Title: **STAGE 1 ROAD SAFETY AUDIT**

Boyne Greenway, Drogheda to Mornington

Client: **DBFL Consulting Engineers.**

Report reference: **1232R01**

TYPICAL CROSS SECTION TYPE A-1 (CH 0 TO 600)

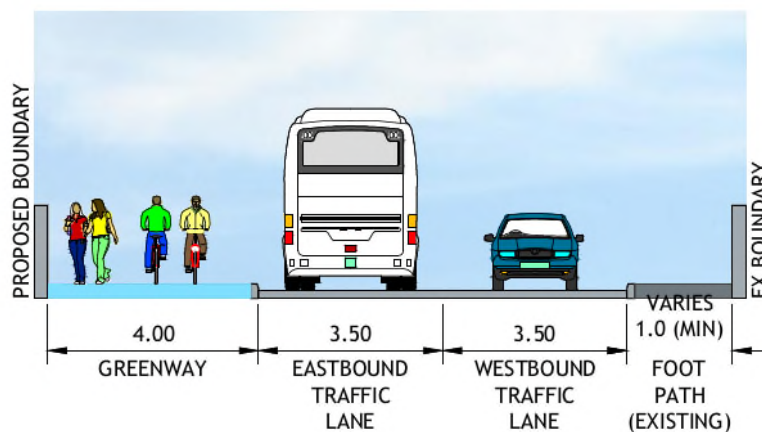
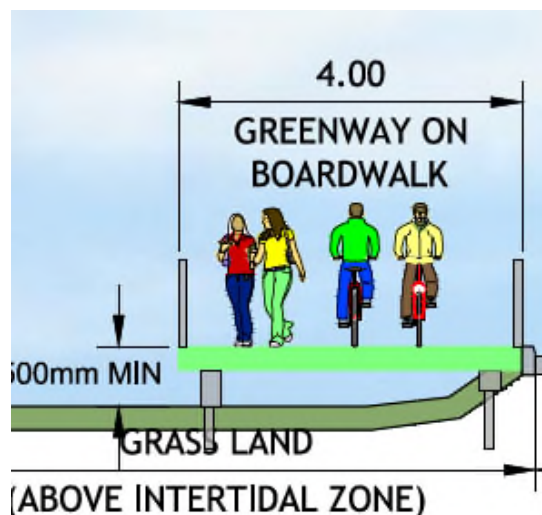
PROBLEM

There is an 80km/hr speed limit on sections of the R150 and generally a 60km/hr speed limit along other sections with a 50km/hr speed limit adjacent to Drogheda Grammar School and at the start of the greenway at the outskirts of Drogheda town.

There is a risk that where the proposed greenway is adjacent to the public road that high vehicle speeds will lead to pedestrians and cyclists being sucked into the carriageway by passing vehicles, especially heavy commercial vehicles or buses.

There is also a very low likelihood of a vulnerable road user surviving a collision with an errant vehicle travelling at 80km/hr or even 60km/hr.

The high vehicle speeds would discourage younger users of the greenway particularly school going children.

It is noted that the design contains raised tables at regular intervals such as side road junctions and crossing points. It is unclear if an overall traffic calming strategy has been assessed based on the spacing and effectiveness of these features.

RECOMMENDATION

It is recommended that this issue be forwarded to the Roads Authority to form part of the next county wide speed limit review. Vehicle speeds should be assessed and additional traffic calming should be provided where excessive speed occurs.

As an interim measure a buffer strip along the kerb edge should be provided to discourage use by pedestrians or cyclists.

A review by the Design Team on the design speeds post the introduction of the proposed traffic calming should be undertaken to see if any additional measures are required.

| Paragraph No. in Safety Audit Report | Problem accepted (yes/no) | Recommended measure accepted (yes/no) | Alternative measures (describe) | Alternative measures accepted by Auditors (Yes/No) |
|--------------------------------------|---------------------------|---------------------------------------|--|--|
| 3.1 | Yes | Yes | As part of this Boyne Greenway scheme, it is proposed to reduce the speed limit of the R150 and R151 to 50km/hr, this will be forwarded to the Roads Authorities to form part of the next county wide speed limit review. In addition, a number of traffic calming features such as table-top ramps have been provided to reduce vehicle speeds. Upon construction of the scheme, and for intervening period until the implementation of the speed limit reduction as outlined, a Temporary Speed Limit Order will be applied to the R150/R151 along the route of the Greenway, which shall reduce the speed limit to 50km/hr. | Yes |

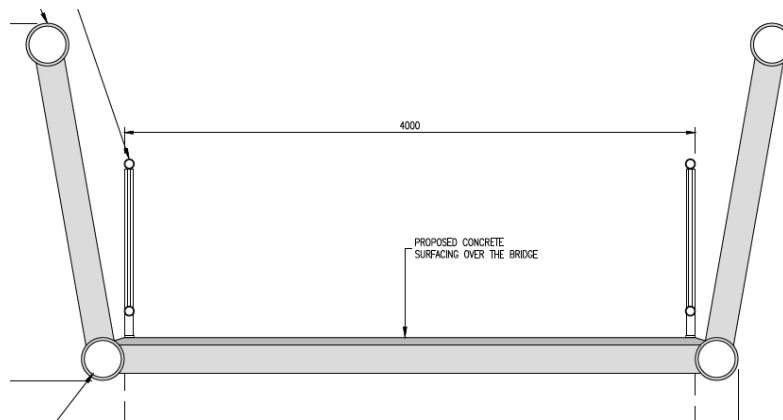
Throughout the scheme, width of the proposed greenway.

It is proposed that the greenway will be 4.0m wide throughout the scheme. In areas where the greenway goes off-line the 4.0m width includes the pedestrian railings and could also include furniture such as lighting columns and life buoys that would be developed during the detailed design stage. There is a risk that the effective width of the greenway along these off-line sections will be much reduced from the on-line sections and that there would be insufficient width for both two-way cyclists and pedestrians. In addition, cyclists may be travelling at relatively high speeds given the flat nature of the proposed greenway and they may not reduce their speed when they enter the tighter off-line sections. This could lead to collisions between cyclists and pedestrians.

It is recommended that the effective width of the greenway be kept constant throughout the scheme.

In addition, where there are any particular interesting viewing areas the cross section should be widened locally to allow people stop and rest (provision of benches) but at the same time let others continue their journey.

| Paragraph No. in Safety Audit Report | Problem accepted (yes/no) | Recommended measure accepted (yes/no) | Alternative measures (describe) | Alternative measures accepted by Auditors (Yes/No) |
|--------------------------------------|---------------------------|---------------------------------------|--|--|
| 3.2 | Yes | No | The width of the proposed greenway has been calculated using the TII Publication "Rural Cycleway Design, April 2017, ref no. DN-GEO-03047. The 4m width is considered to meet/exceed the minimum desirable width of 3m for low volume routes (i.e. < 1,500 daily users). Lighting columns will not be provided within the greenway. | Yes |

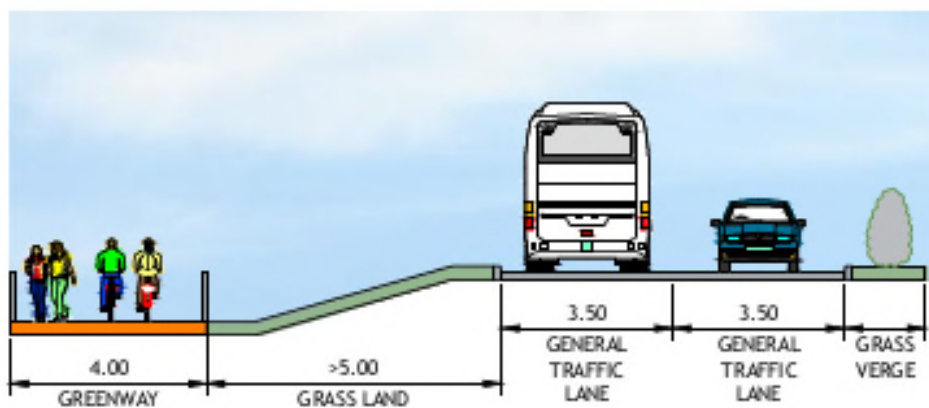
General, throughout the scheme adjacent to the Boyne estuary.

At some locations along the scheme the existing road is close to the banks of the River Boyne. At some locations there is a vertical drop at the edge to the bed of the river/mud plains. There are also some tributary crossings with retaining walls/headwalls along the route. There is a risk that an errant vehicle could enter the river bed and there could be a secondary effect if the tide was high of drowning or of the vehicle not been seen by passing drivers given the height difference.

Where the greenway is located beside the existing road there is a risk that the removal of a bund may lead to an increased risk of an errant vehicle reaching the river/floodplain.

It was observed during the site visit that there is a high kerb along some sections of the existing public road. It is unclear if such a kerb is adequate to provide containment for errant vehicles.

It is recommended that risk assessments are carried out on the need to provide protection for errant vehicles from entering the river bed at various locations along the scheme. This should include the approach and departure lengths to parapet/retaining walls. Based on the outcome of the risk assessments suitable containment should be provided.

The use of high kerbs should take account of the speed limit and the containment rating (N1, N2 or otherwise) of the kerbs.

| Paragraph No. in Safety Audit Report | Problem accepted (yes/no) | Recommended measure accepted (yes/no) | Alternative measures (describe) | Alternative measures accepted by Auditors (Yes/No) |
|--------------------------------------|---------------------------|---------------------------------------|---|--|
| 3.4 | Yes | No | The proposed greenway will create more protection from potential errant vehicle entering the river bed than the existing layout. The scheme proposes a 4m wide boardwalk with kerbs and fencing along this point. The boardwalk will be able to cater for vehicular loads, for emergency access. Therefore, the boardwalk will create an additional 4m clear zone. | Yes |

Drawing 170029-2205 Rev P2, Sideroad at Chainage 630.

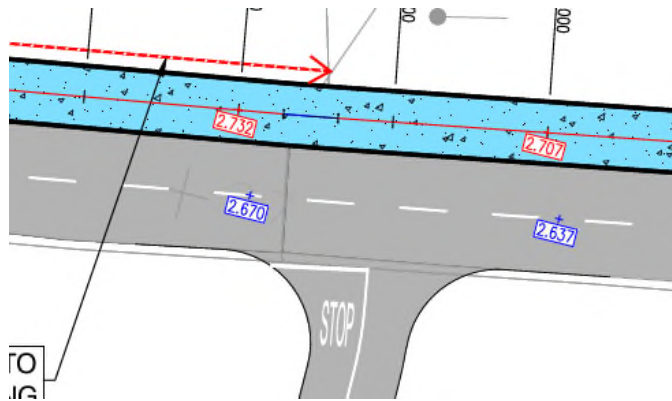
There is a proposed sideroad at Ch 630 on the opposite side of the R150 to the greenway. No means of accessing the greenway is shown on the drawings. Without an access point, vulnerable road users may have to stay on the carriageway where they would be at greater risk of being struck by passing traffic.

It is recommended that a suitable crossing/access to the Greenway be provided.

| Paragraph No. in Safety Audit Report | Problem accepted (yes/no) | Recommended measure accepted (yes/no) | Alternative measures (describe) | Alternative measures accepted by Auditors (Yes/No) |
|--|---------------------------------|--|---|--|
| 3.7 | Yes | No | This sideroad is a future private development. When the road/development is further progressed, discussions between the development and the Roads Authority will be undertaken to determine a suitable safe crossing facility. | Yes |

Drawing 170029-2218 Rev P5, Access to Marsh Road/Mill Road Junction.

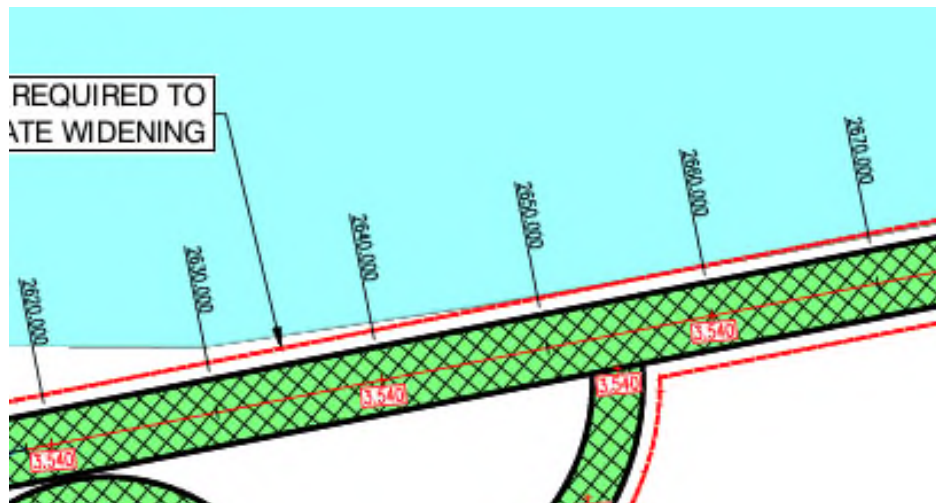
It is proposed to provide a spur from the boardwalk element of the greenway to the signalised crossing of Marsh Road to the East of the Mill Road junction. The turn into the spur from the main greenway may be difficult for cyclists given its width and the presence of the railings. This could lead to collisions with the railings or collisions with other cyclists or pedestrians.

It is recommended that the junction with the greenway spur be widened locally to facilitate cyclists turning movements.

| Paragraph No. in Safety Audit Report | Problem accepted (yes/no) | Recommended measure accepted (yes/no) | Alternative measures (describe) | Alternative measures accepted by Auditors (Yes/No) |
|--|---------------------------------|--|---|--|
| 3.8 | Yes | Yes | | |

Drawing 170029-2227 Rev P2, Typical cross section.

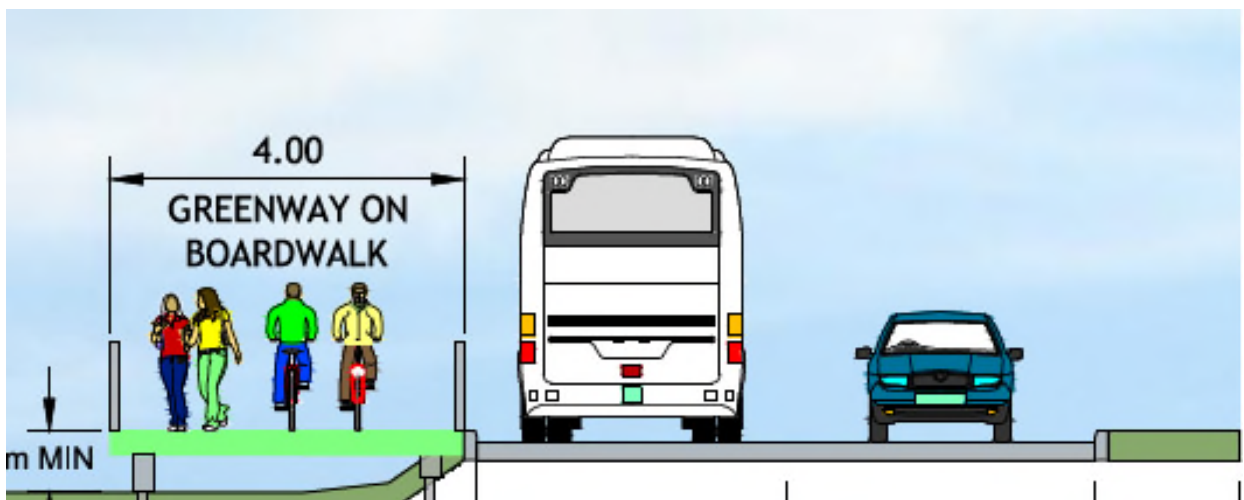
The typical cross section East of the R150 Church Road junction shows the boardwalk and carriageway separated by a pedestrian railing and a kerb. There is a risk that the railing will be damaged by a large vehicle given how small of an offset it has from the edge of the carriageway. This could also lead to injury to pedestrians or cyclists.

It is recommended that the railing of the boardwalk be set back further from the edge of carriageway.

| Paragraph No. in Safety Audit Report | Problem accepted (yes/no) | Recommended measure accepted (yes/no) | Alternative measures (describe) | Alternative measures accepted by Auditors (Yes/No) |
|--|---------------------------------|--|---|--|
| 3.10 | Yes | No | 450mm buffer will be provided between the carriageway edge and the boardwalk railing. The timber rails will be placed on the boardwalk/greenway side of the posts. | Yes |

Drawing 170029-2235 Rev P3, Footpath on Southern side of R151.

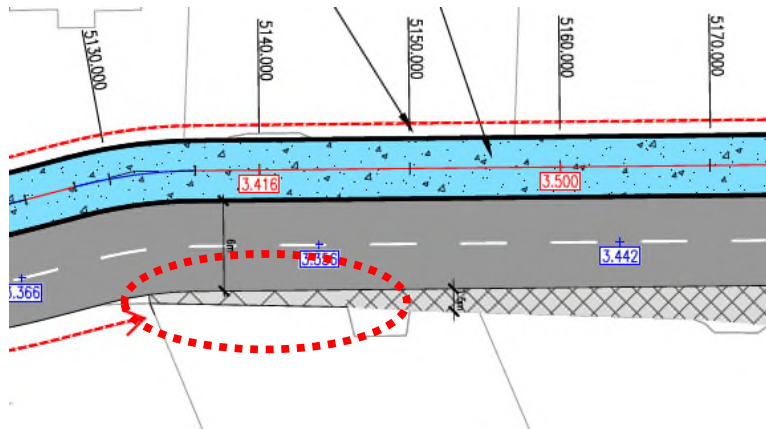
It is unclear where the footpath will terminate on the southern side of the R151 but it is expected at approximately Ch 5140. There is a risk that pedestrians may continue their journey towards Drogheda on the carriageway if there is no facility for them to cross to the greenway on the opposite side. This would lead to an increased risk of those pedestrians being struck by passing vehicles.

It is recommended that an uncontrolled crossing point be provided at the terminal of the footpath at a location where suitable inter-visibility is provided between pedestrians and drivers.

| Paragraph No. in Safety Audit Report | Problem accepted (yes/no) | Recommended measure accepted (yes/no) | Alternative measures (describe) | Alternative measures accepted by Auditors (Yes/No) |
|--|---------------------------------|--|---|--|
| 3.11 | Yes | No | A zebra crossing to the greenway is provided at the Mornington Court access. Providing a pedestrian crossing at the location mentioned will encourage the two residential properties on the southern side of the R151 to cross at a location where vehicle speeds have not | Yes |

| Paragraph No. in Safety Audit Report | Problem accepted (yes/no) | Recommended measure accepted (yes/no) | Alternative measures (describe) | Alternative measures accepted by Auditors (Yes/No) |
|--|---------------------------------|--|--|--|
| | | | been calmed due to proposed traffic calming. | |

Drawing 170029-2237 Rev P4, Bus stop facilities.

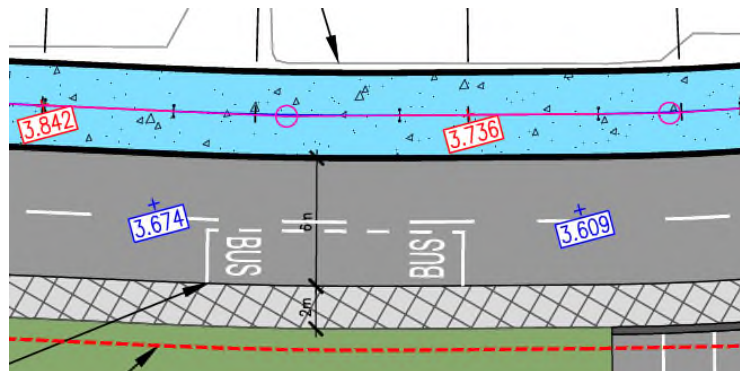
It is unclear if a pedestrian crossing point is to be provided between the greenway and the Drogheda bound bus stop at Ch 5450. Without suitable crossing facilities the bus may not be accessed by all.

It is recommended that a pedestrian crossing be provided adjacent to bus stop.

| Paragraph No. in Safety Audit Report | Problem accepted (yes/no) | Recommended measure accepted (yes/no) | Alternative measures (describe) | Alternative measures accepted by Auditors (Yes/No) |
|--|---------------------------------|--|--|--|
| 3.12 | Yes | Yes | | |

Drawing 170029-2202 and Site Observation.

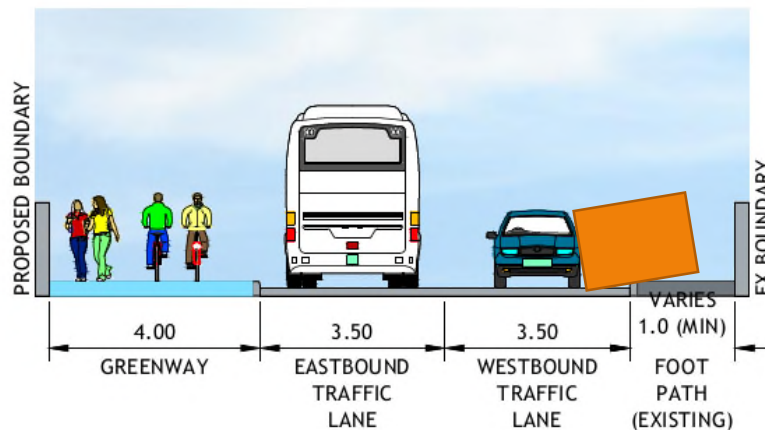
It was observed during the site visit that on-road parking takes place on the Marsh Road outside the houses adjacent to Weir Hope. There are no on-curtilage parking facilities at some of those houses. It is unclear if the carriageway will be narrowed at this location as a result of the greenway or will remain the same. A lack of parking provision may lead to parking on the footpath resulting in hazards for pedestrians.

It is recommended that the scheme design takes account of this parking and that provision be made for it.

| Paragraph No. in Safety Audit Report | Problem accepted (yes/no) | Recommended measure accepted (yes/no) | Alternative measures (describe) | Alternative measures accepted by Auditors (Yes/No) |
|--|---------------------------------|--|--|--|
| 3.13 | Yes | No | Prior to providing the exiting cycle facilities there were yellow lines (parking restriction) on both sides of the carriage at this location. Residents at this location have existing parking spaces at the rear of their properties. | Yes |

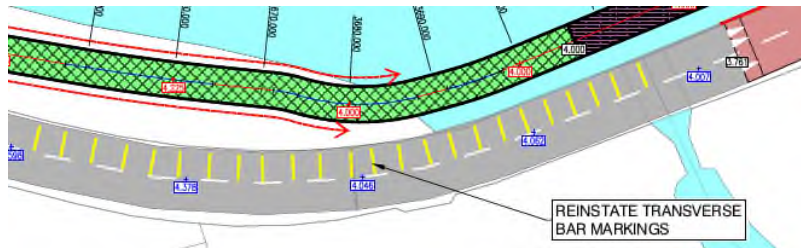
The use of transverse bar markings is currently only permitted on dual carriageway approaches to roundabouts. Alternative forms of traffic calming may be required on approach to the R150/R151 junction.
